DRAWN & DRAFTED BY	Lu PenG	TOLERANCES	ANGLE: $\pm 1^\circ$	TITLE: SMD BOBBIN EFD-15		
CHECKED & APPROVED BY		$0 < L \leq 4 \quad \pm 0.1$ $4 < L \leq 16 \quad \pm 0.2$ $16 < L \leq 63 \quad \pm 0.3$	UNIT: MM	BOBBIN MATERIAL: PHENOLIC PM-9630	UL REC. UL 94V-0	
PIN SHINE INDUSTRIAL CO., LTD.			ORIGIN: DG	PIN MATERIAL: PHOSPHOR BRONZE	PIN TENSION LOAD: 1.0KG MIN	
TEL: 886-2-22990545 FAX: 886-2-22990546				DATE: APR.04 '2003	DRAWING NO. S-1502	REV. 5

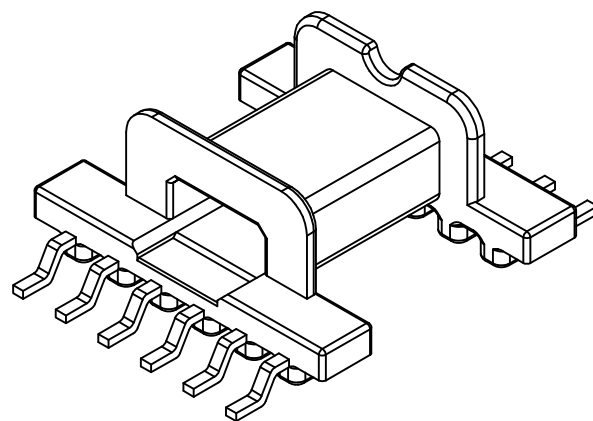
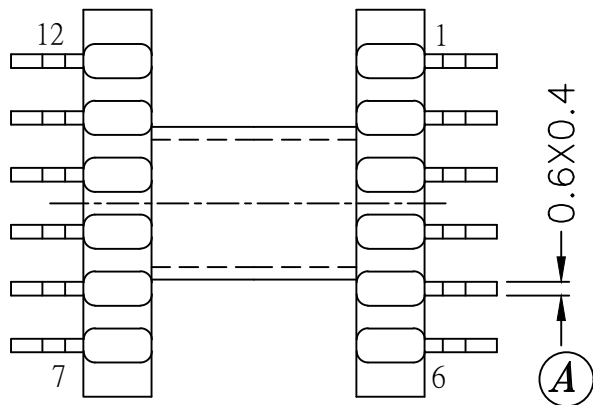
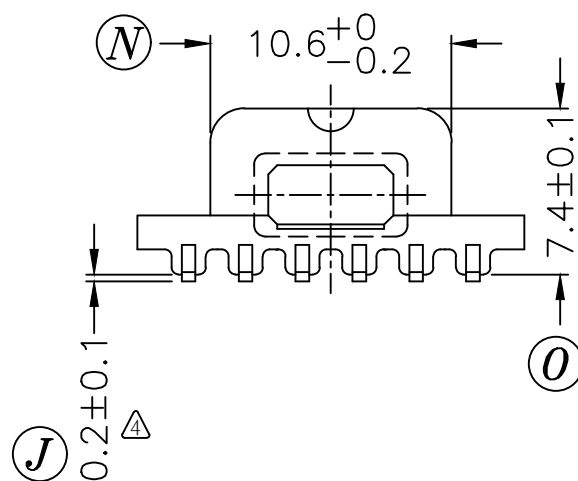
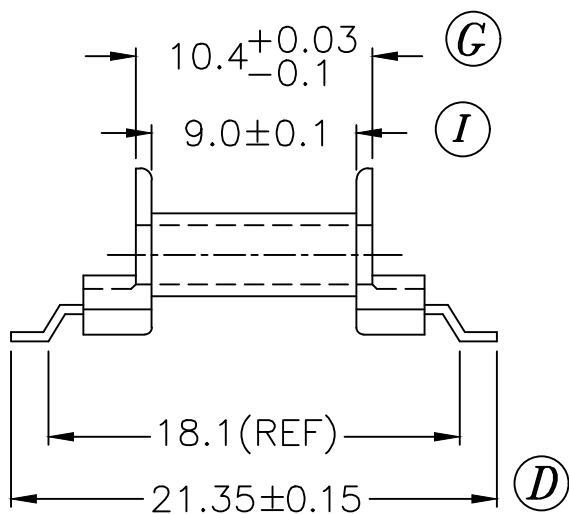
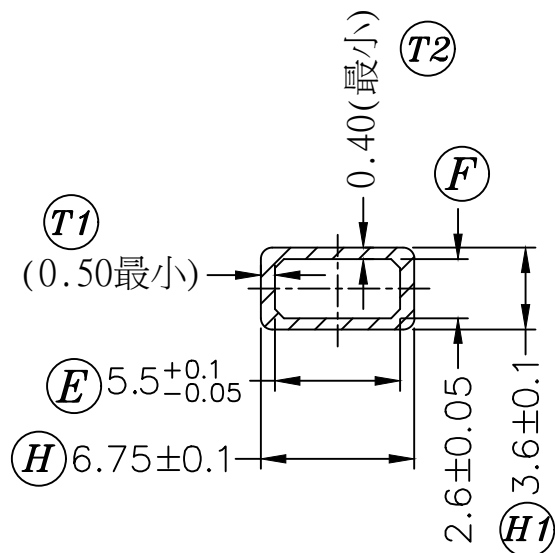
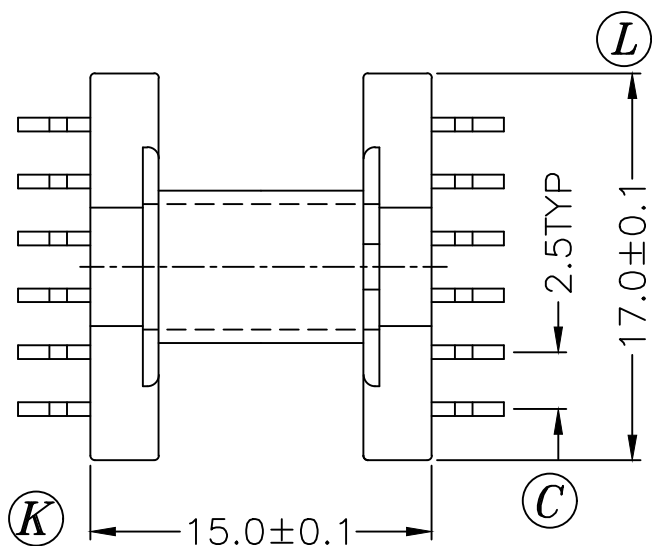
REV.	REVISIONS REC.	DATE	REV.	REVISIONS REC.	DATE
1.	(B): $21.35^{+0}_{-0.2}$ CHANGE TO 21.35 (E): $5.5^{+0.1}_{-0}$ CHANGE TO 5.5. (F): $2.6^{+0.1}_{-0}$ CHANGE TO 2.6 (G): 10.4 ± 0.1 CHANGE TO 10.4. (H): 6.75 ± 0.1 CHANGE TO 6.75 (I): 9.0 ± 0.05 CHANGE TO 9.0. (M): 2.7 ± 0.05 CHANGE TO 2.7	02.2.20	3	PIN TENSION LOAD: 1.5KG CHANGE TO 1.0KG MIN.	04.8.10
2	CANCEL (M),(D); UPDATE DRAWING	03.5.15	4	CHANGE 0.15MIN----> 0.2 ± 0.1 (triangle symbol)	12.04.25
			5	UPDATE DRAWING BY THE HORIZONTAL DRAWING.	12.05.28
